CONDUIT PLAN

ROADWAY LEVEL EASTBOUND LIGHTING AND ELECTRICAL SYSTEMS

CONTRACT CHANGE ORDER No. 170
 SHEET _____ OF _____

ROADWAY LIGHTING POLE LOCATION PLAN-SHEET 43
LIGHTING AND ELECTRICAL SYSTEMS
 NO SCALE

6 REVISED PER ADDENDUM NO. 6 DATED OCTOBER 30, 2001
EE-43

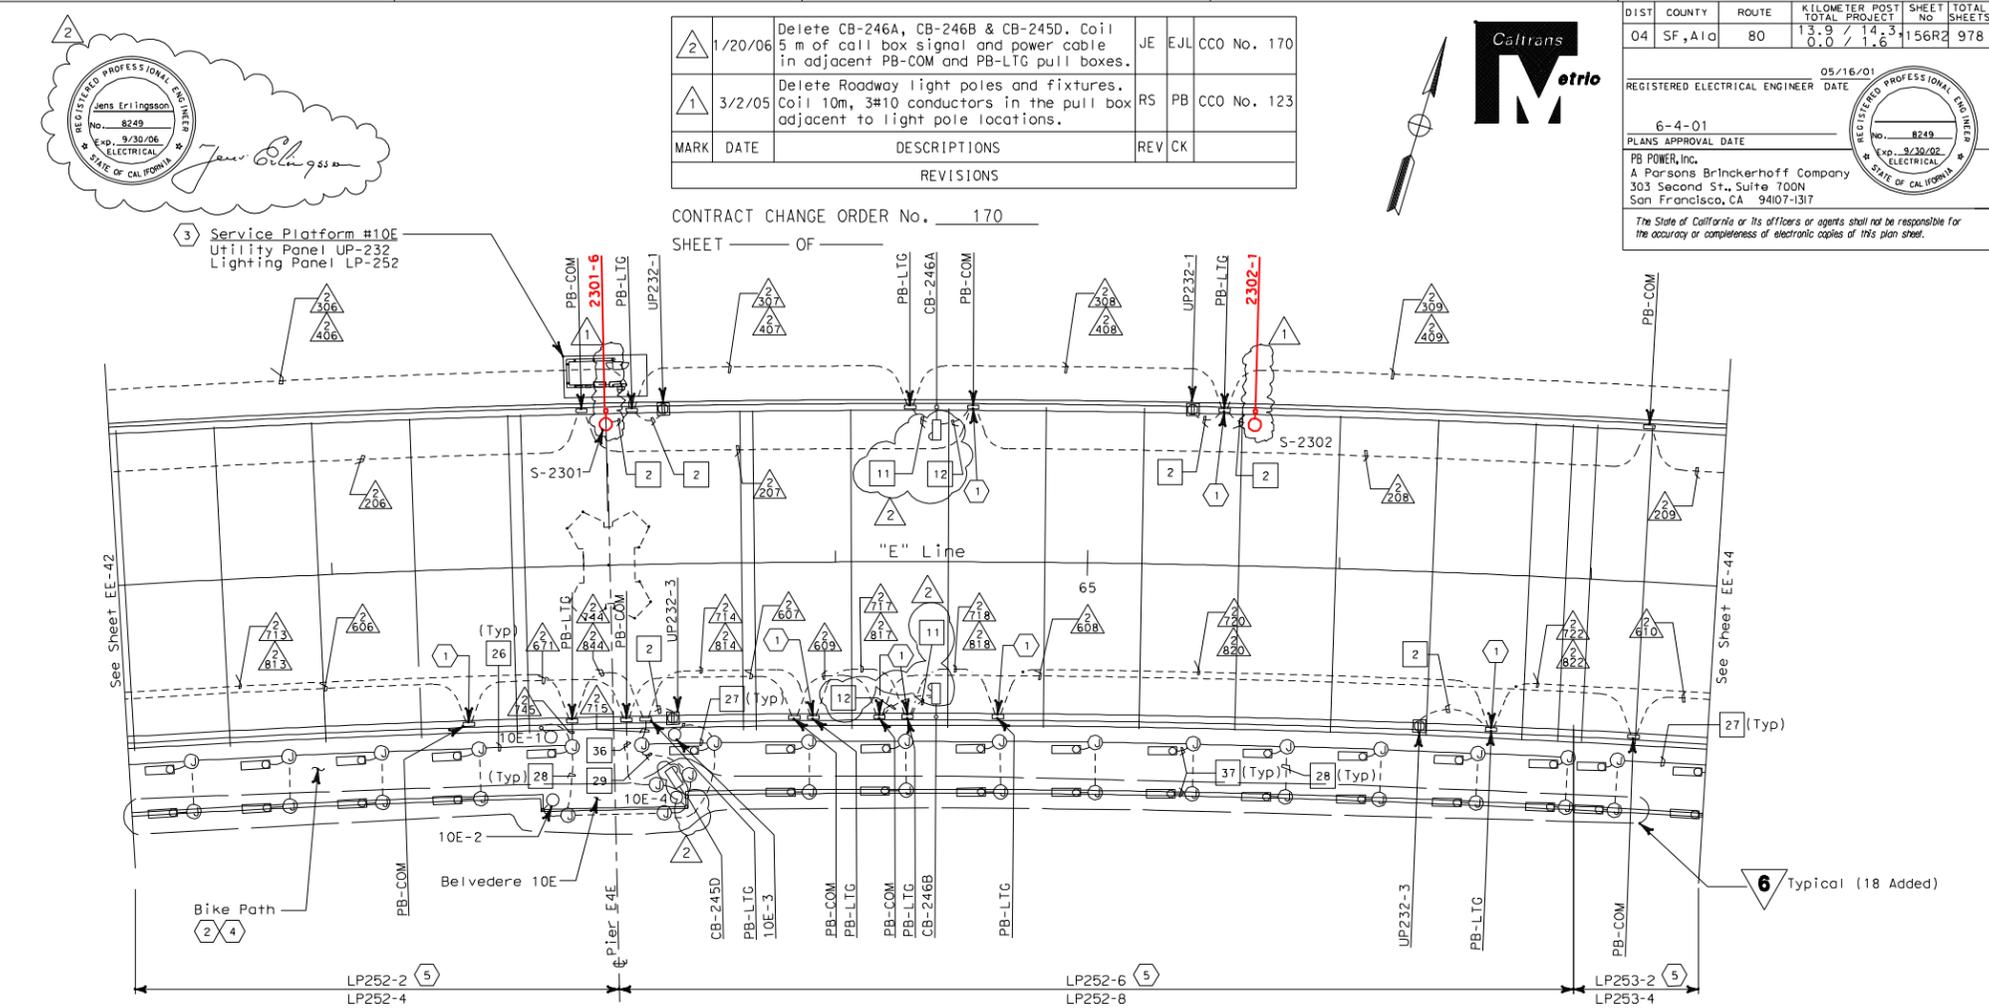
MARK	DATE	DESCRIPTIONS	REV	CK
2	1/20/06	Delete CB-246A, CB-246B & CB-245D. Coil 5 m of call box signal and power cable in adjacent PB-COM and PB-LTG pull boxes.	JE	EJL
1	3/2/05	Delete Roadway light poles and fixtures. Coil 10m, 3#10 conductors in the pull box adjacent to light pole locations.	RS	PB
